File RZP-1996-157

Name: Horizon Village – SE Corner of 7<sup>th</sup> Street / Horizon Drive – Rezone/Preliminary Plan

FIGURE 2

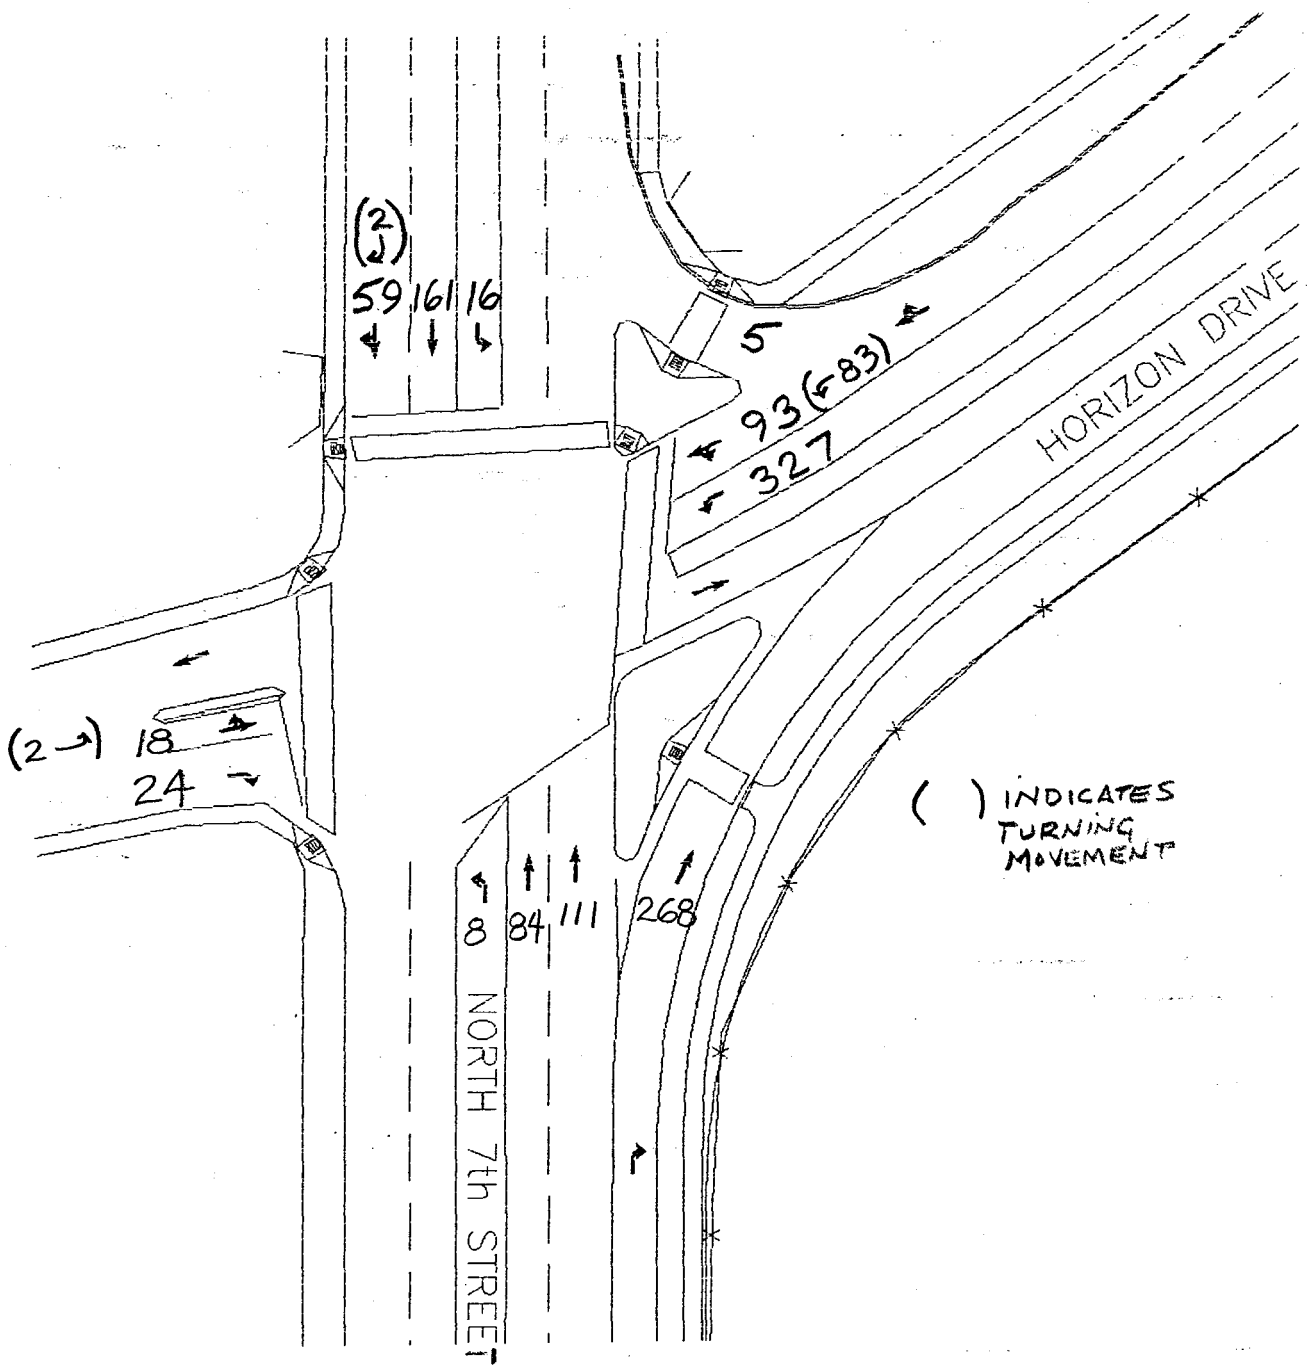
11. On Figure 2, please indicate the turning movement breakdown for the shared lanes. If the turning movement count data is available, please include in the appendix.

FIGURE 3

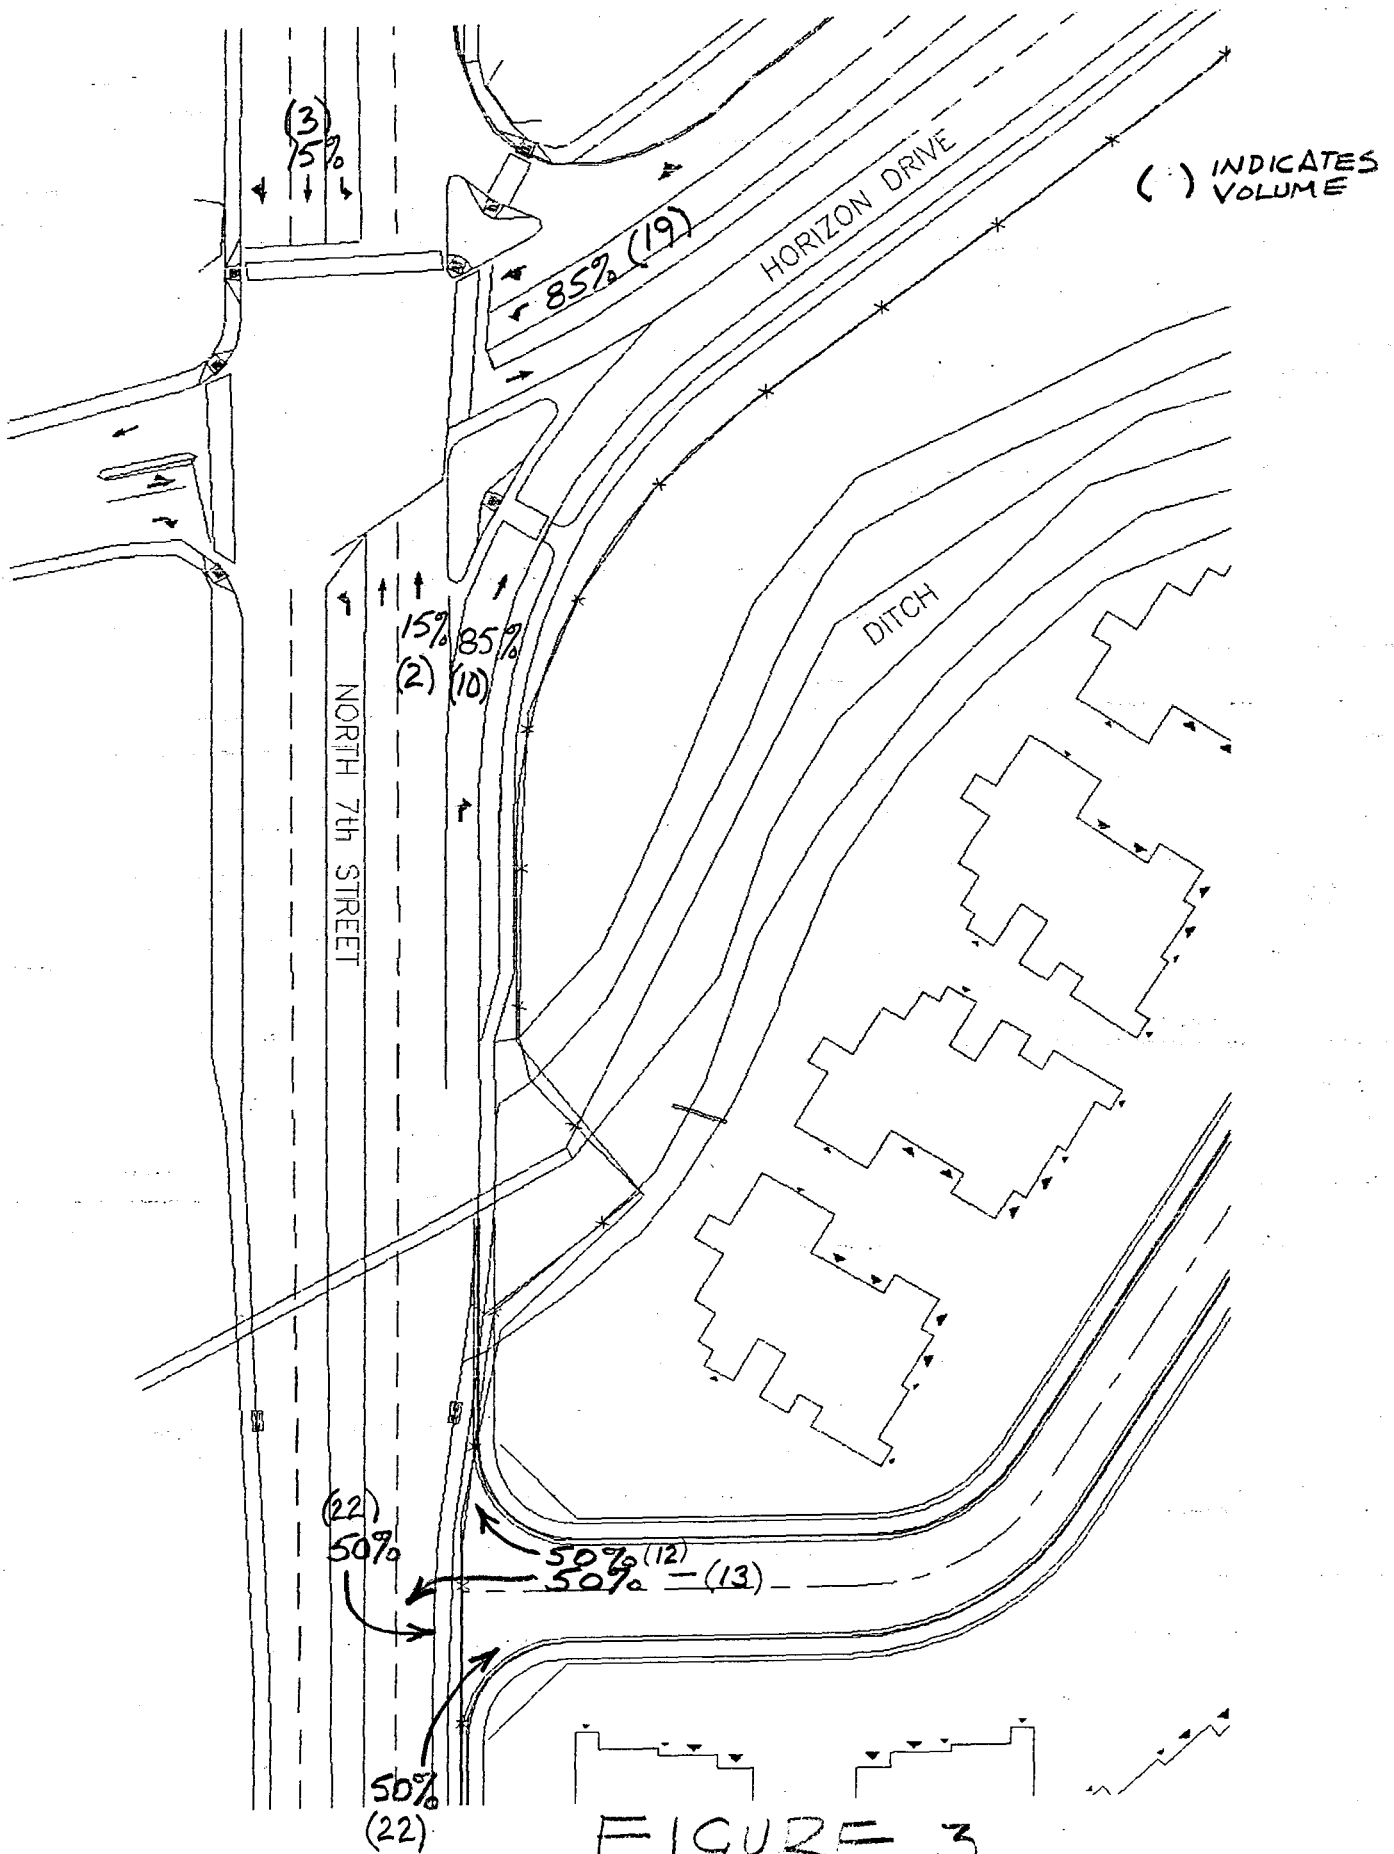
12. On Figure 3, please include a legend. A separate figure for trip assignment and trip distribution is preferable.
13. Please label Figure 4 so it is clear that it is existing plus site traffic and indicate the hour. The same comment for figure 5. Same comment about breaking out the turning movements in the shared lanes as in comment 11.
